COMMENT SET 15

PRC-421 Revised Project - Review of January 2004 DEIR

REVIEW of the 2004 DRAFT ENVIRONMENTAL IMPACT REPORT

REF: "4.6-9 Bottom"

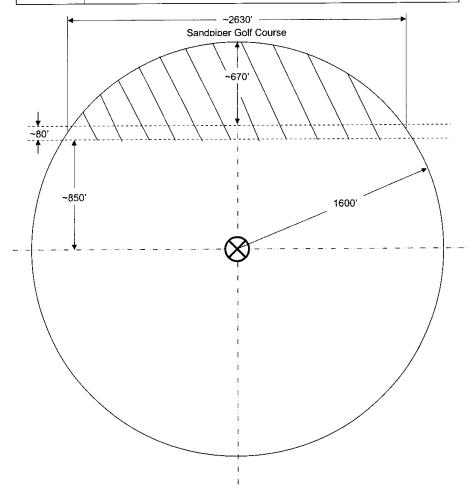
4.6-9 Bottom	Comment	This section states that locations within 1600' of the construction site would be affected by noise above 65dB. The project site is approximately 850' seaward from shore and the adjacent bluffs are approximately 80' from landward from shore. The site is generally isolated from the public, with limited access. The remaining landward portion of the 1600' radius covers a land area of only 26 acres (see sketch at end). The Bengal Engineering report (CSLC application binder, page 98) states that total driving time per pile would be 64 minutes, however this may be spread out over a period of two hours or so. Please see earlier comment under Page 1-23 NOI-1.	15-52

Shaded Area ~ 26 Acres

- 15-52. In the impact assessment portion of the DEIR Noise Section, it is acknowledged that, due to the distance between the project site and sensitive receptors, most of

- the construction noise would not be significant. However, because pile driving would result in noise levels above that typical for construction equipment, noise levels during this phase only would exceed thresholds at sensitive receptor sites within 1,600 feet of the site. See also Response to Comment 15-10 herein.
